Subject: MIL OR LOW FUEL LIGHT MAY ILLUMINATE, INACCURATE/ERRATIC OPERATION OF FUEL GAUGE	Bulletin No: 01-007/01R
	Last Issued: 8/30/2002

All 1997 - 2002 Millenia

Revision Note: 2002 Millenia has been added to the applicable models.

FUEL GAUGE SENDING UNIT

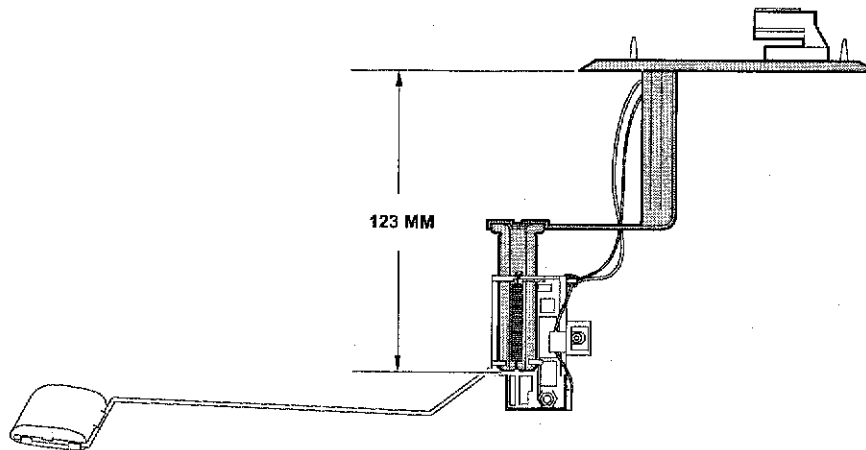
6. Measure distance between bottom edge of fuel gauge sender unit bracket and bottom mounting surface of mounting plate as shown in the following illustration.

- If measurement is 123mm (plus or minus 1mm) bracket is not bent. For further diagnosis refer to Service Bulletins 09-003/00R and/or F(01)-016/98.
 - If measurement is 112 to 121mm, replace fuel gauge sender unit with modified part. DO NOT replace fuel tank. Proceed to STEP 8.
 - If measurement is less than 112mm, reinstall fuel gauge sender unit back into fuel tank and proceed to STEP 7.
7. Check evaporative system for excessive vacuum using the following procedure:
- A. Warm-up engine to normal operating temperature.
 - B. Using NGS Tester, monitor PIDs for RPM, PRGV & FTPV.
 - C. With vehicle in PARK, rev fully warm engine and hold at 2800RPM for 3-4 minutes.

Repair or replace any parts found causing a restriction. Then replace fuel tank using modified part number and replace fuel gauge sender unit using new original part number. See PART(S) INFORMATION. Install new original fuel gauge sending unit into modified fuel tank.

- If vacuum readings DO NOT indicate a restriction, install a new fuel gauge sending unit using new original part number into a modified fuel tank using modified part number. See PART(S) INFORMATION.
